#### 1 Products affected

#### 2 Type of change

Product Change Notification						PCN DF12		
owner	creation date	release date	released by	change order no	rev	page	D10-001-303	
hotzar	2016-02-01	2016-02-01	hotzar	2009053	Α	1 of 2

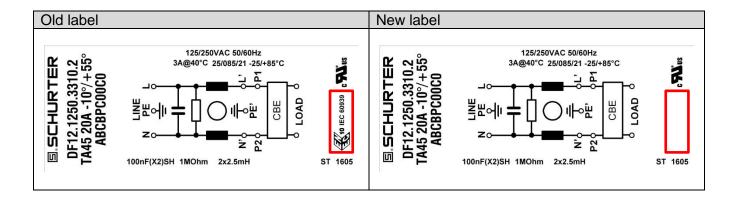
Temporary loss of the VDE approval for TA45 circuit breakers without bimetals (C00 Types) and / or relays (A, E, and U, relays) used in power entry module DF12.
